PCN-20201003 TE0890-01 SPI Flash Change

Company	Trenz Electronic GmbH
PCN Number	PCN-20201003
Title	TE0890-01 SPI Flash Change
Subject	BOM change
Issue Date	2020-10-06

Locate Flash (U6) at top side of PCB:

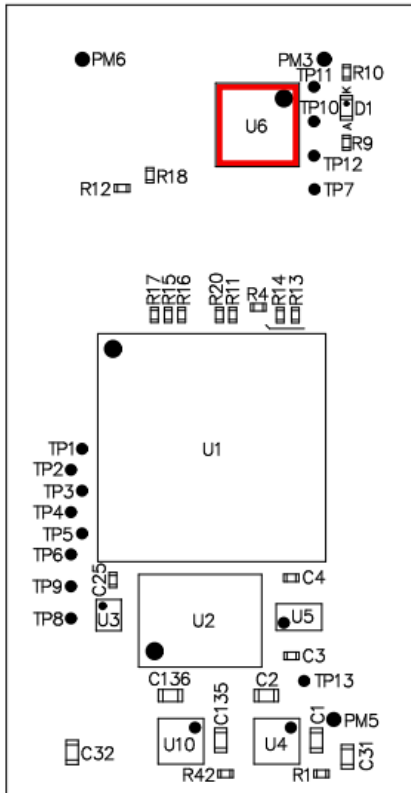
#1 Change SPI Flash from N25Q064A13ESE40F to IS25LP064D-JBLE

Reason: Old flash is obsolete.

Impact: JEDEC ID changes from BA17h to 6017h and manufacturer ID from 20h to 9Dh.
